ADDENDUM NO. 2
TO
CITY OF AUBURN, MAINE
LONGLEY BRIDGE UNDERPASS/COURT & MAIN STREET INTERSECTION
IMPROVEMENTS PROJECT
April 2, 2009

This addendum amends and/or supplements the bid documents as indicated below. Only these items alter the Bid Documents. Any verbal discussions or responses are hereby declared null and void.

CLARIFICATIONS TO THE BID DOCUMENTS:

VIEWS AND DETAILS OF THE DETECTABLE WARNING

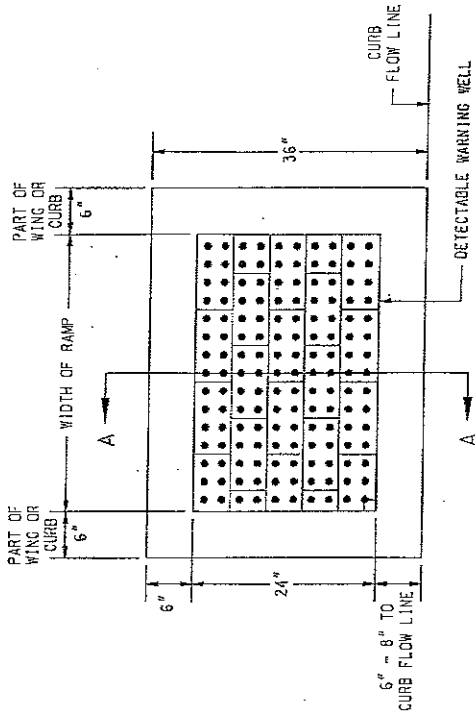
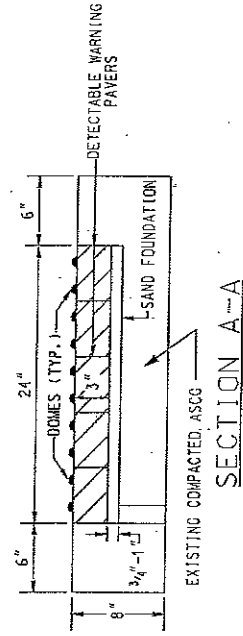
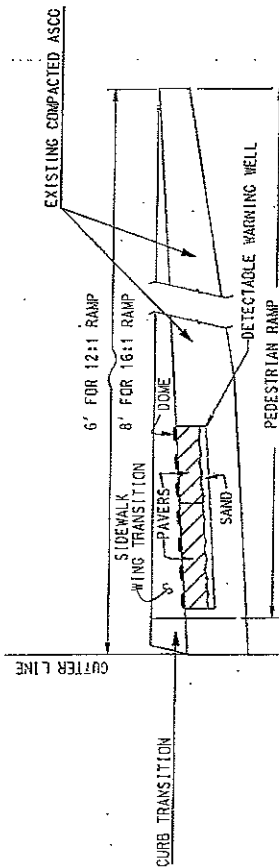
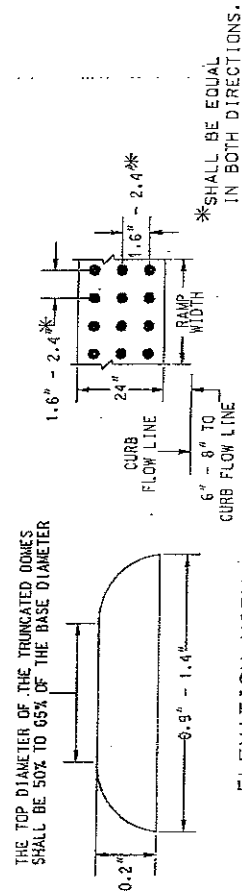
16. *Can the City provide additional information regarding the detectable warning surfaces at the crosswalk locations?*

Additional information is included in this addendum regarding detectable warning surfaces, including a detail and special provisions.

NOTE:
ALL DETECTABLE WARNING AREAS SHALL START 6 INCHES FROM THE FLOW LINE OF THE CURB, AND BE 24 INCHES IN DEPTH, AND COVER THE COMPLETE WIDTH OF THE RAMP AREA ONLY.
